CCK-2874.00-3-25 New Environmental Quality Management Center BP02 ADDENDUM #1 05/01/2025

## ADDENDUM #1

project UK Environmental Quality Management Center

# 1 SECOND FLOOR LIGHTING PLAN E2.2 1/8" = 1'-0"

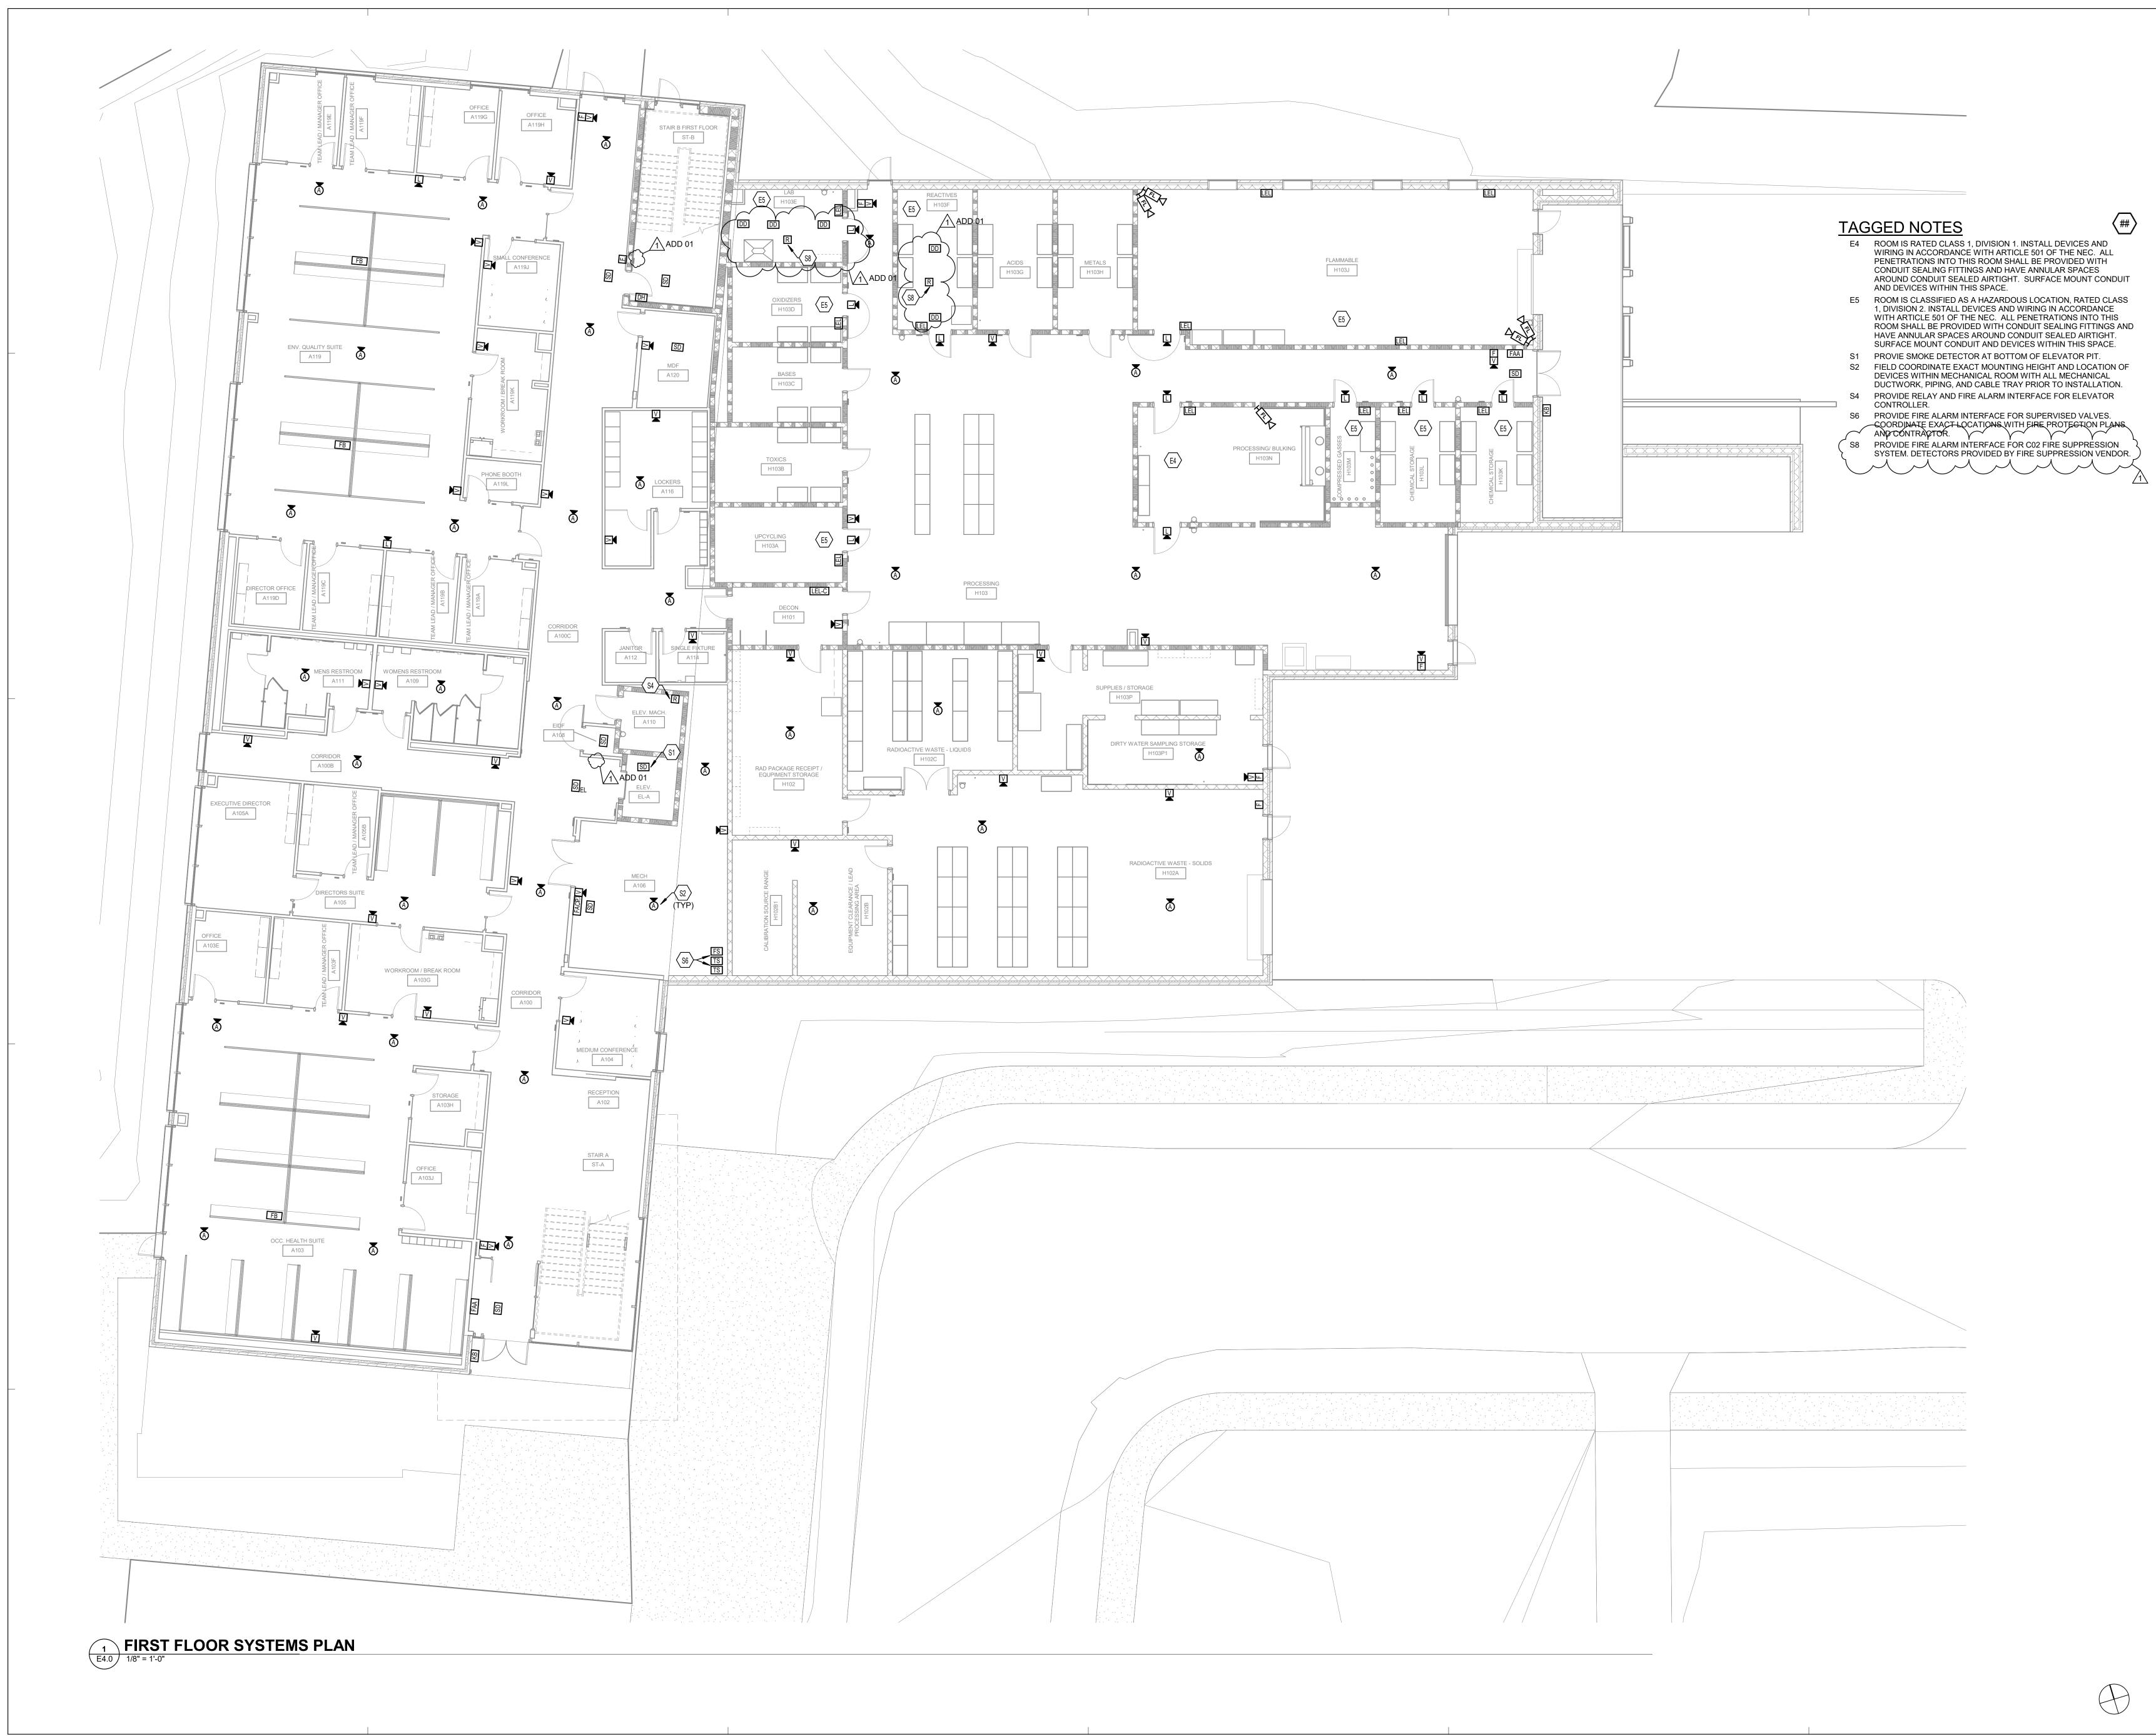
- Item #7 Refer to sheet E2.2 SECOND FLOOR LIGHTING PLAN ALTERNATES
  - A. Edited luminaire schedule to include columns for Alternate Manufacturer and Mounting.

- B. Changed visibility of base bid lighting to clarify that it is only to be included in the base bid.
  - C. Changed light fixtures in plan south portion of breakroom to be type H.

**1** SECOND FLOOR SYSTEMS PLAN - ALTERNATES E4.1 1/8" = 1'-0"

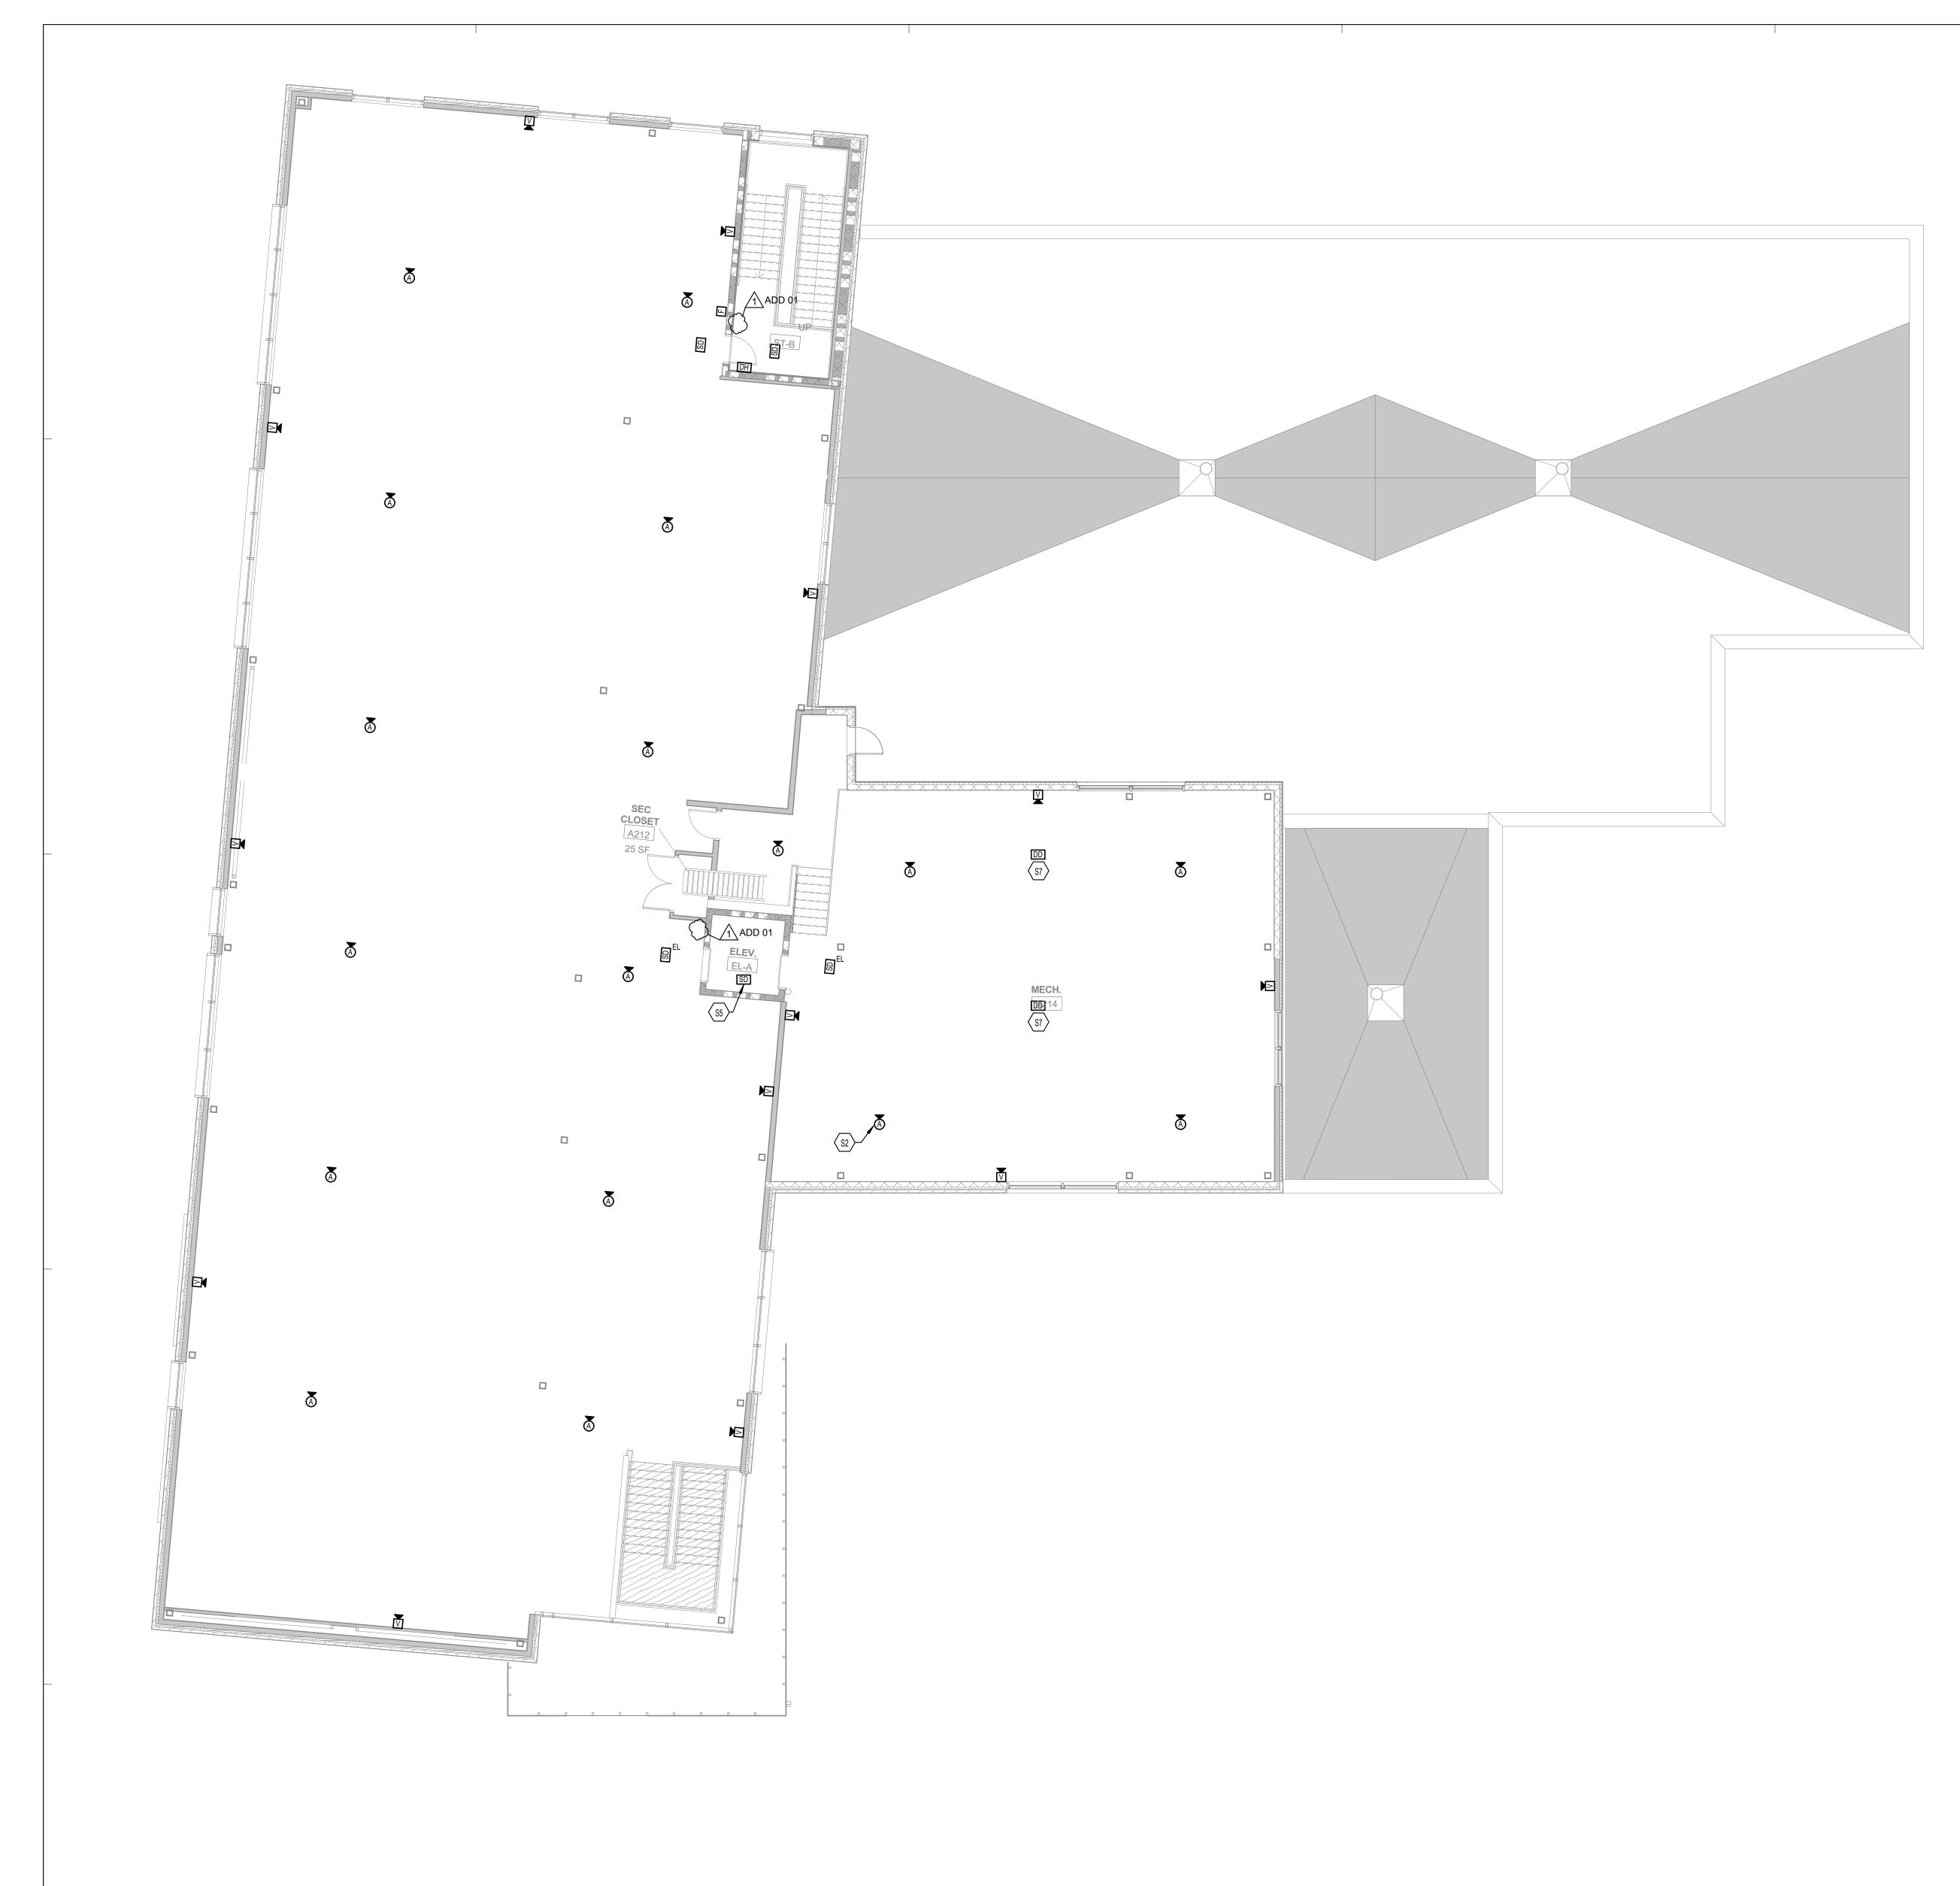
- A. Deleted firefighter phone jacks at elevator and stairwell.
- Item #10 Refer to sheet E4.1 SECOND FLOOR SYSTEMS PLAN ALTERNATES
  - A. Deleted firefighter phone jacks at elevator and stairwell.
